Item # **5**
MCPB 3-30-06

MEMORANDUM

REVIEW TYPE: **Site Plan Review**
 CASE #: **820060010**
 PROJECT NAME: Montgomery Auto Sales Park (Herb Gordon Auto World-Mile One)
 Automobile Boulevard
 APPLYING FOR: Approval for Development of Lot 17 of the Auto Park with 57,749 Square
 Feet of Auto-Related Uses (Body Shop & Service Center)
 REVIEW BASIS: Div. 59-D-3 of Montgomery County Zoning Ordinance
 Div. 59-C-4.36 and 59-C-4.367 (Special Regulations) of Montgomery
 County Zoning Ordinance
 ZONE: C-3 (Highway Commercial)
 LOCATION: Approximately 1200 feet south of the Automobile Boulevard/Briggs
 Chaney Road intersection in Silver Spring.

Rendered Perspective

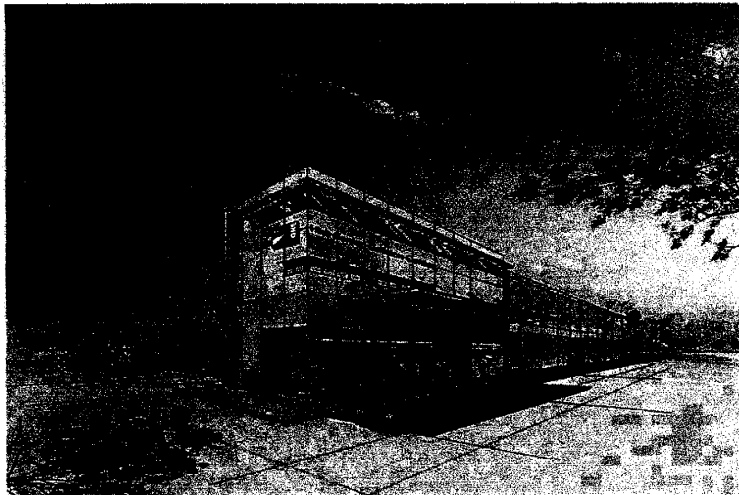
However, the plan also shows an area behind the landscaped strip along the Briggs Chaney Road frontage and in front of the main building, for display and/or storage of automobiles. The area is defined with a special pavement treatment to distinguish it from the asphalt drive aisles and striped parking space areas located behind the front wall of the main building and on the rooftop in compliance with the Code. The applicant has indicated that customers, employees and other visitors to the site would not be permitted to park in this area. Rather, vehicles, such as sales dealership inventory, that are not moved for longer periods of time than those associated with the more routine, in and out traffic, would be "stored" in this area, partially screened from sight by the landscaped area between it and Briggs Chaney Road.

The staff has determined that the proposal to store automobiles for sale by the dealership, which is on another lot, does not meet the definition of "automobile sales lot". Therefore, the area identified as Special Paving Treatment Area in front of the building, which is proposed for

storage of automobiles which will not be sold on the subject premise, is a parking facility and must be removed from the front yard area of the service center building.

* The 21 spaces shown in front of the main building are prohibited by Zoning Code and must be removed. Therefore, the site plan and data table must be revised to reflect this prior to Certification of Plan.

- c. The parking tabulations shall be revised to eliminate the 19 spaces identified as display (Special Paving Treatment) as well as the two spaces in the front corner, northeast side of the building. Revise the total number of spaces to 424 spaces.

- d. Revise site plan and parking table to eliminate all parking spaces shown in front yard of building, per 59-C-4.365.
- e. Label setbacks from all property lines. Show the measurement control point for building height on the site plan. Show building footprint dimensions and lot coverage calculations not to exceed 35%, per 59-C-4.367(b).
